Report to the Future Melbourne Committee

Planning Permit Application: TP-2020-533 6-10 MacArthur Place North, Carlton

16 March 2021

1. The purpose of this report is to advise the Future Melbourne Committee of a planning permit application seeking approval for partial demolition, external alterations, and buildings and works to construct three dwellings on a lot at 6-10 MacArthur Place North, Carlton (refer attachment 2 – Locality Plan).

Figure 20 – Level 1 north wall windows (original window locations shown in green; openings to party walls shown with blue arrows)

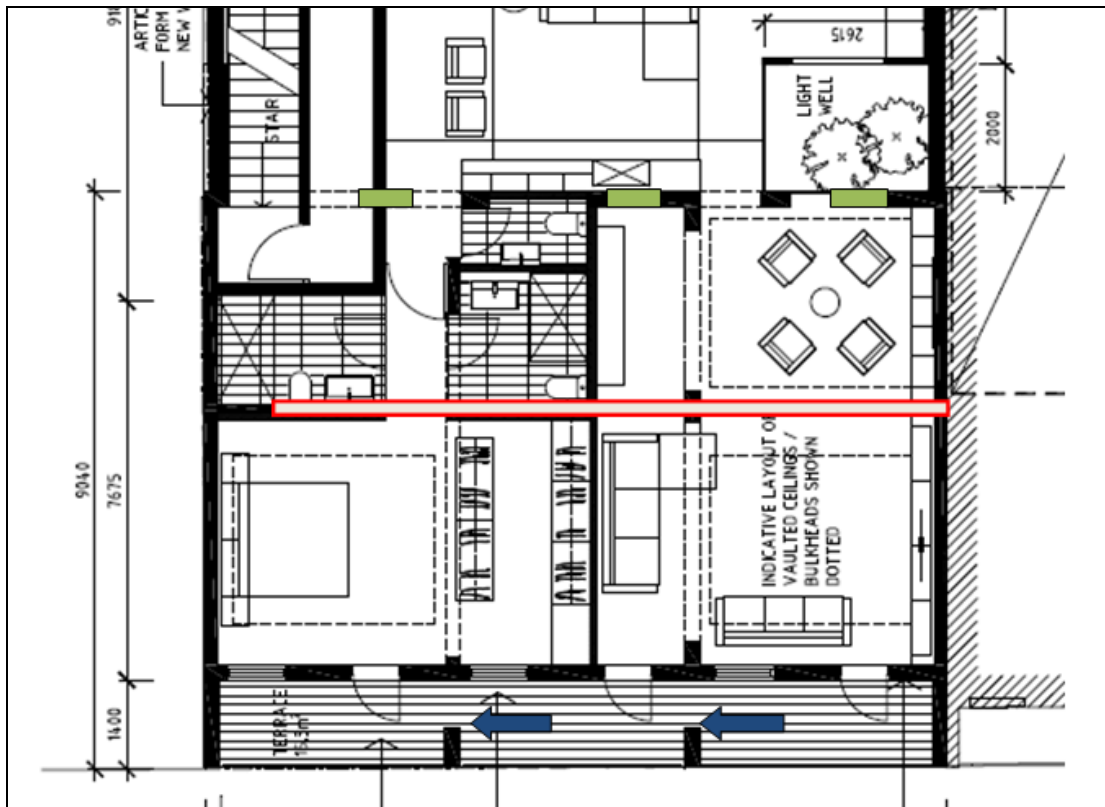
- It is recommended the parapet termination points be retained through a permit condition.
- The City of Melbourne's Heritage Advisor noted the north wall windows at Level 1 as being original. They commented that all three windows should be retained and identified the windows at 6 and 8 MacArthur Place North could be retained without significantly impacting the proposal's floor plan layout (Figure 20). Given the window for No. 6 is located adjacent to a light well, it is agreed this original window should be retained.

- It is recommended a condition be included on any permit that requires the north window of Level 1 of 6 MacArthur Place North be retained.
- The City of Melbourne's heritage advisor has raised issue with the demolition of the brick party walls at the ground and first floor verandahs (Figure 20 and 21).

Figure 21 – Ground level plan showing proposed demolition to verandah party walls

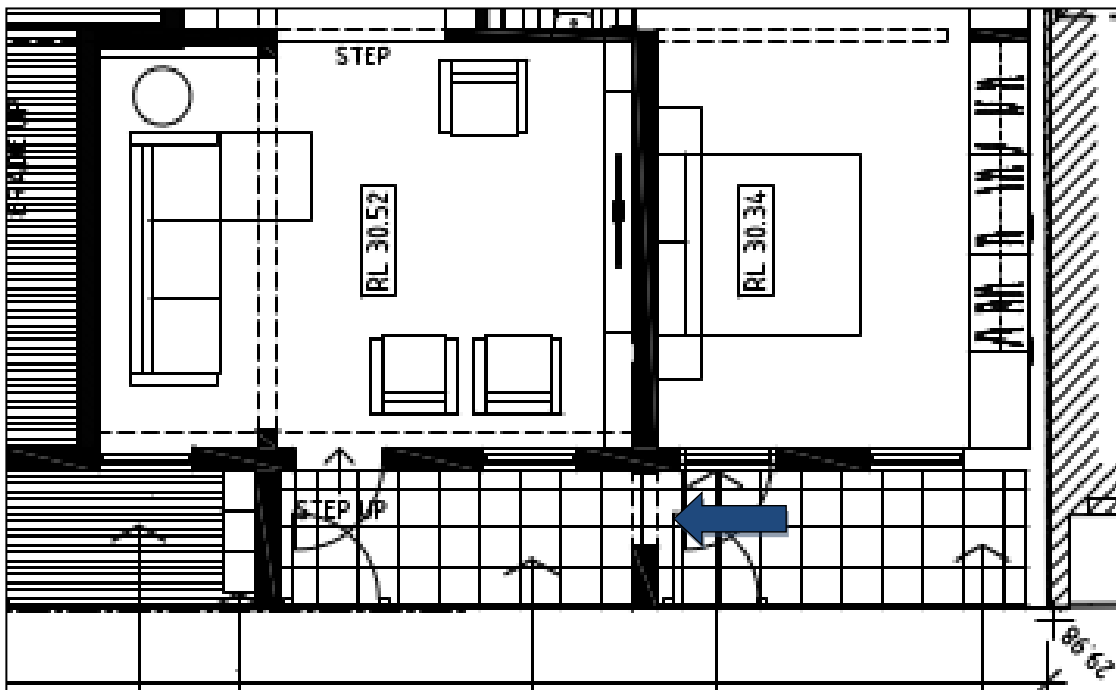
- b. Delete the proposed openings to the verandah party walls. (Blue arrows See Figure 5.)
 - c. Amend the drawings to show the face brick wall surfaces and bluestone trims.

Figure 25 – Proposed sightlines

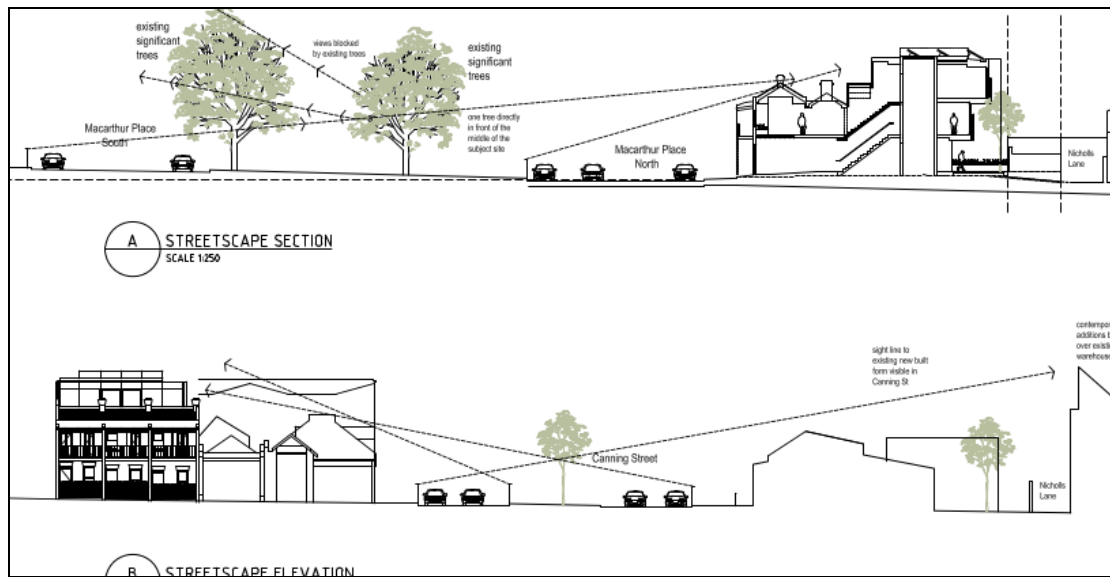
The proposed addition is partly concealed behind the existing heritage building; this is appropriate (Figure 25). While the addition will be visible from the intersection of Canning Street and Nicholls Lane, the visibility of the structure will not unreasonably detract from the character of Canning Street or Nicholls Lane or dominate the adjacent buildings.

Figure 26 – Rear elevation showing east side setback requirement (red) (Note: structures constructed to the boundary are not part of the setback assessment)

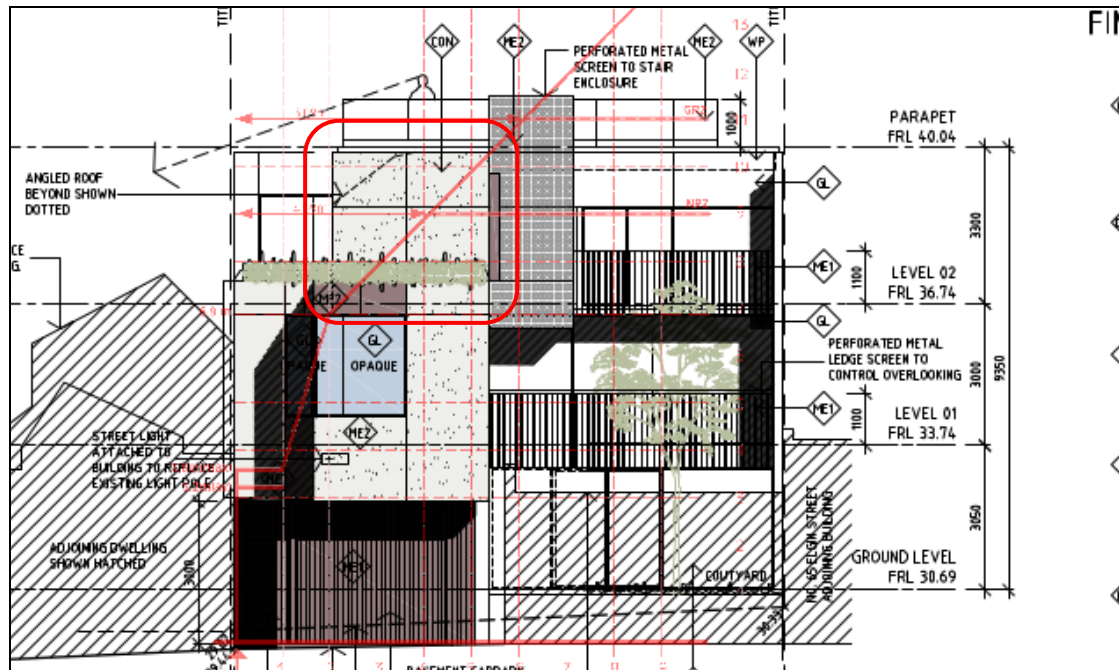
The rear (north) wall at Level 2 is 10.1 metres above the ground and is setback 1.2 metres from the north boundary. This wall is required to be set back 5.79 metres from the north boundary (Figure 26).

Figure 27 – East elevation showing rear setback requirement (red) (Note: structures constructed to the boundary are not part of the setback assessment)

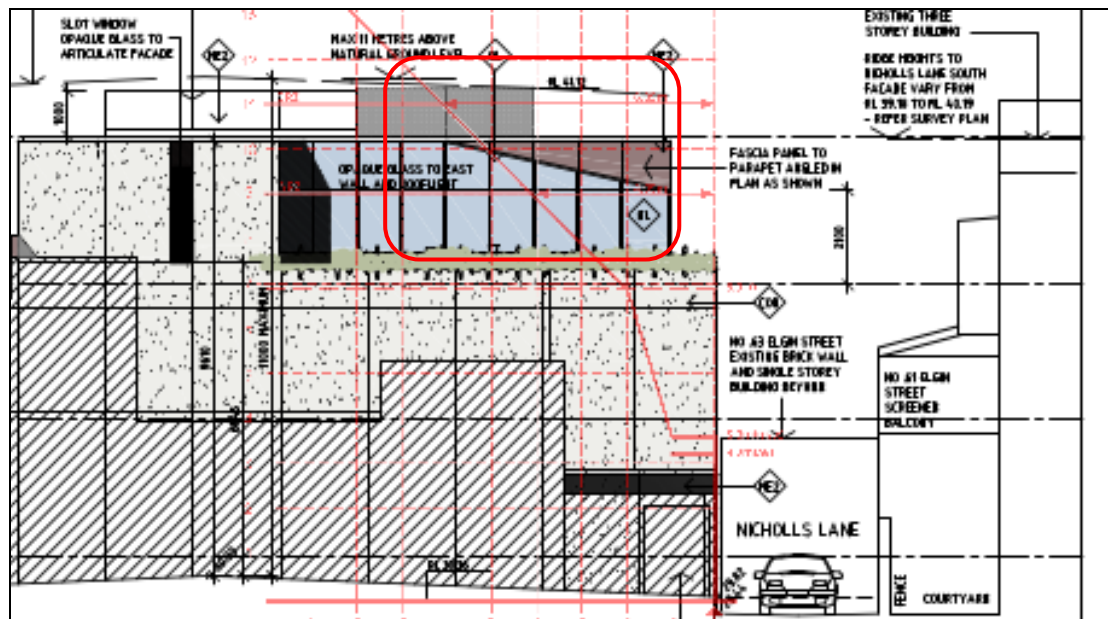
The structure at the rear of Level 1 has an east wall that is 7.3 metres high and setback 1.8 metres from the east boundary. This wall is required to be set back 2.39 metres from the east boundary (Figure 27).

Figure 28 – Proposed section showing distance greater than 9 metres from overlooking source to nearest habitable room window or secluded private open space

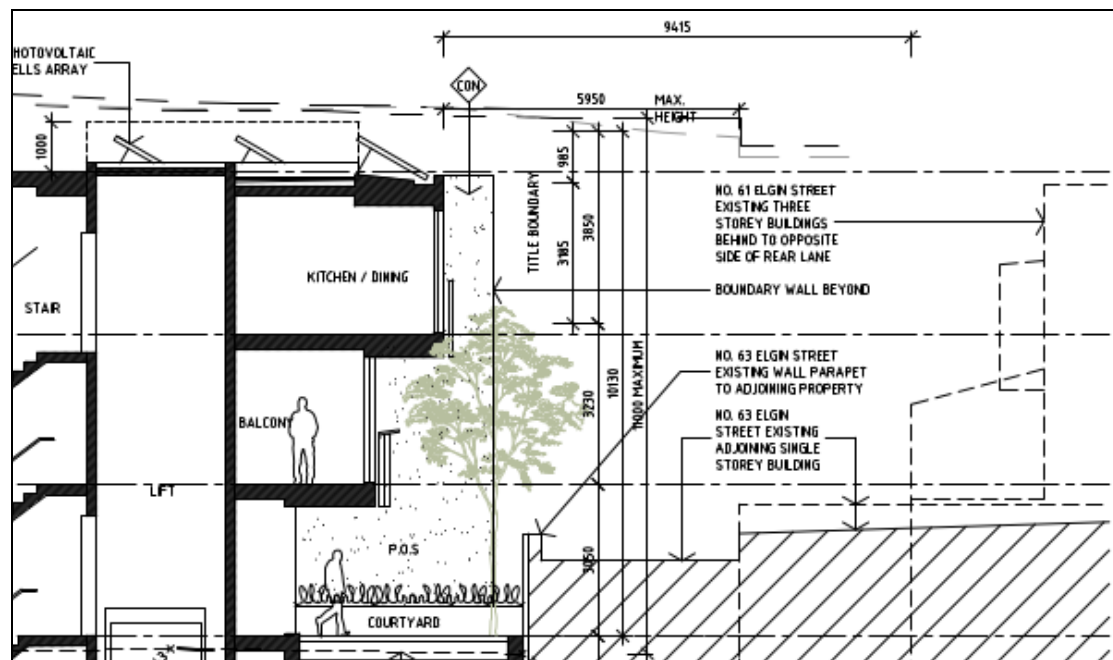
facing balconies at Level 1 and 2 are greater than 9 metres from any adjoining habitable room window or secluded private open space (Figure 28)

Figure 29 – Proposed rear opaque glazing

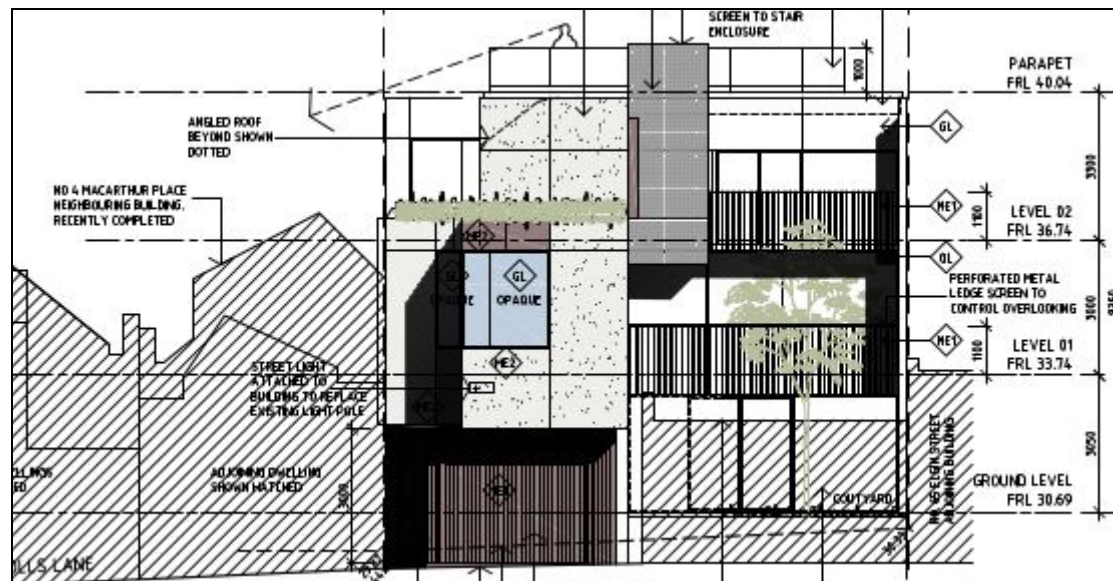
The proposal contains opaque glazing applied to the north and east windows at Levels 1 and 2 (Figure 29). The location of the terrace balustrade and fixed planters ensure that direct views to the east adjoining property's secluded private open space is not possible. No other point of potential overlooking is within 9 metres of an adjoining habitable room windows or secluded private open space.

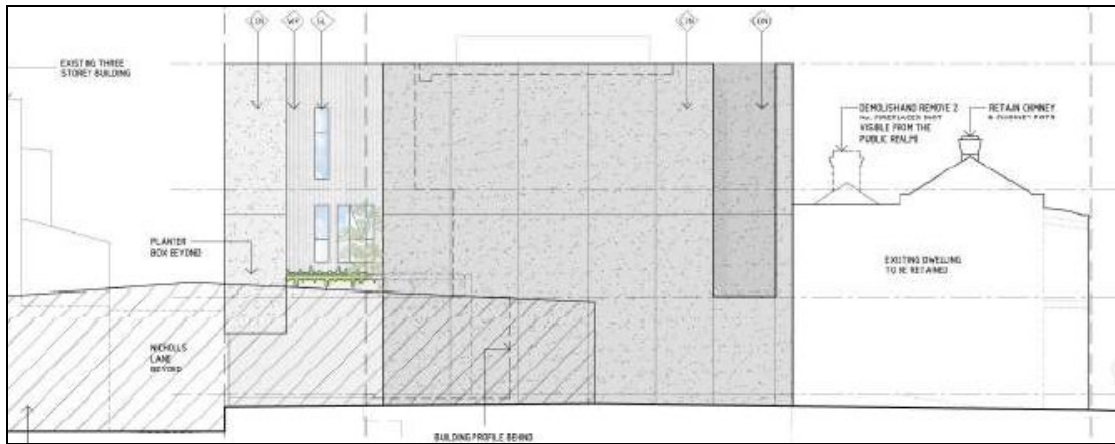
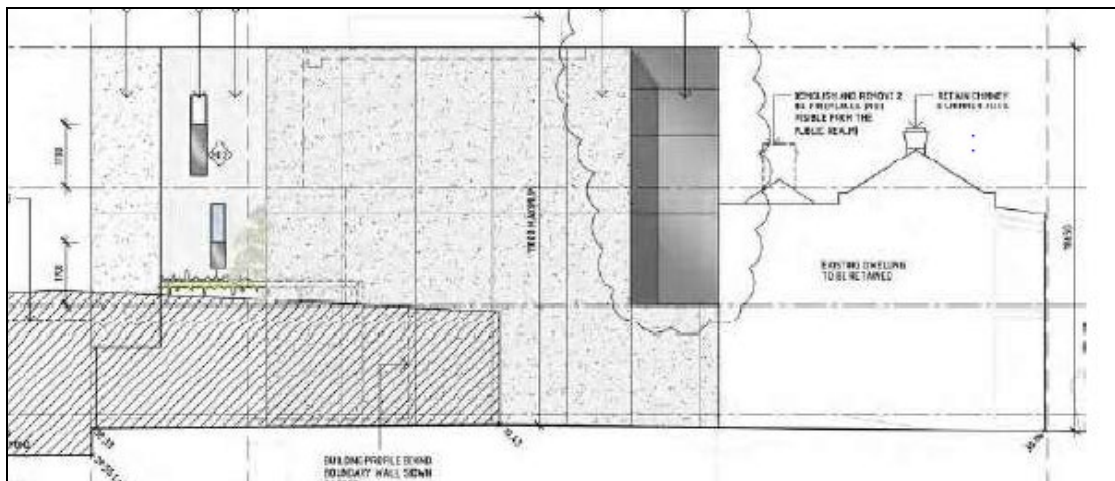
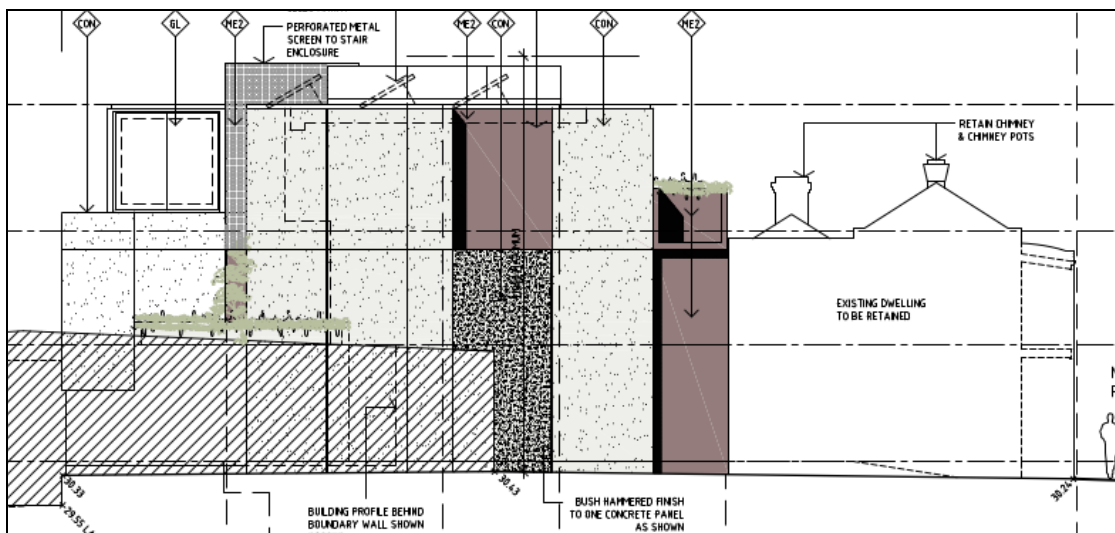
The images below show the progression of the west elevation from the original submission for TP-2018-59, to the elevation prepared for that application's VCAT hearing, to what is proposed under this application (Figures 30, 31, and 32). The proposed west elevation successfully avoids mass and bulk through ensuring blank walls are minimised. This is achieved by:

Figure 33 – 85th percentile turning circle

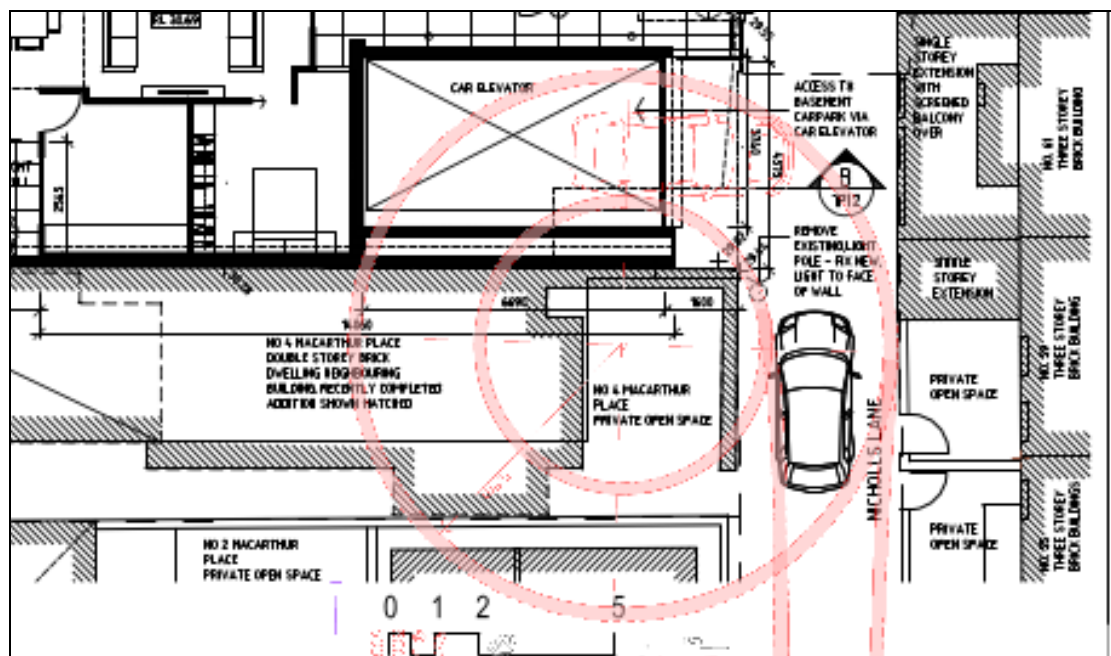
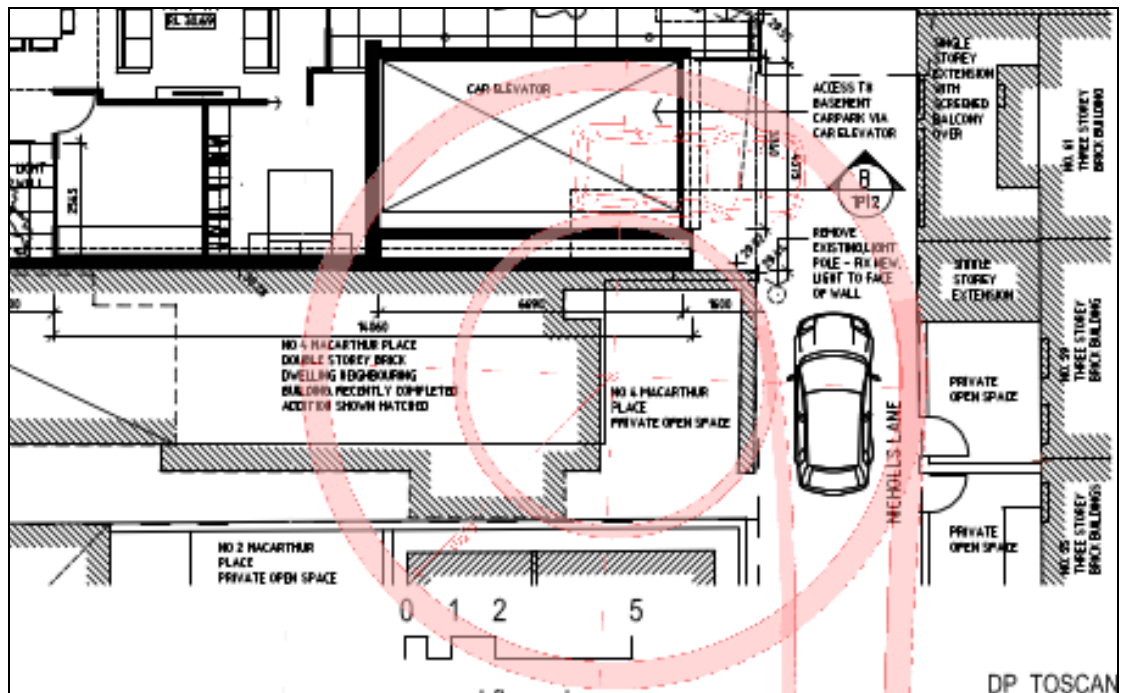
9. The proposed car parking provision does not require a permit in this instance and the limited on-site car parking will not result in unreasonable or unsafe traffic conditions.

Figure 35 – Aerial image of 2-10 MacArthur Place North, Carlton

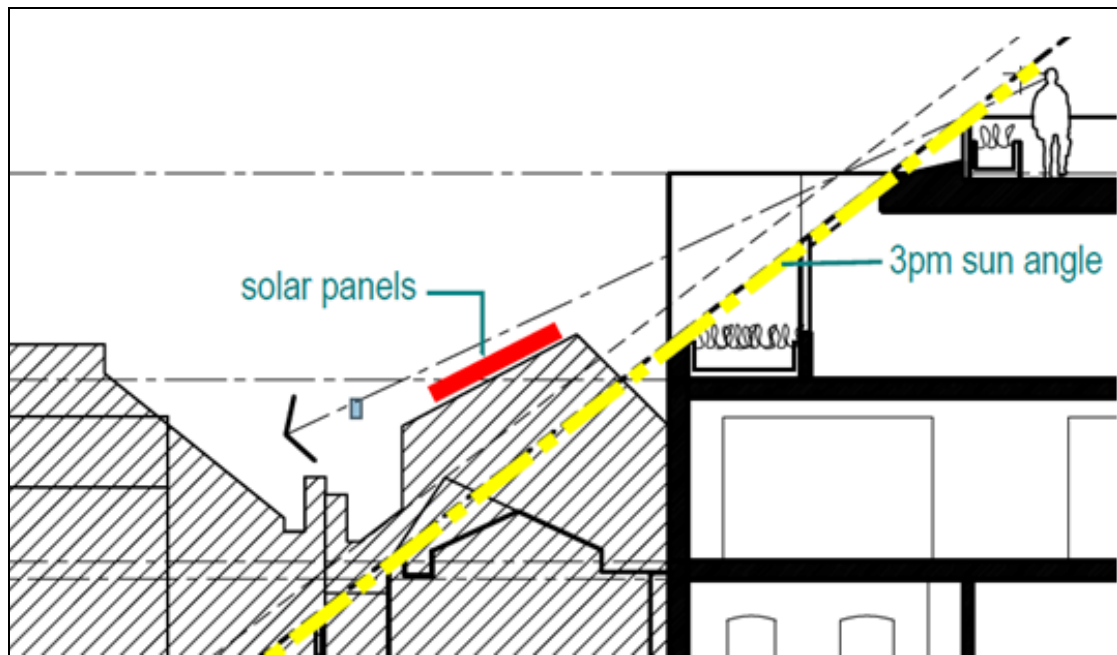
It has been confirmed there are existing solar panels at 4 MacArthur Place North, Carlton which are approved by planning permit TP-2015-1031 (Figure 35).

The applicant provided the following section showing the 3pm equinox Sun angle (Figure 36). The section drawing showing the sun’s angle at 3pm demonstrates the structure would not cast a shadow on the solar panels that are located on the east slope of the building. The panels would receive reasonable solar access throughout the hours of the day that overshadowing is assessed under (9am to 3pm).
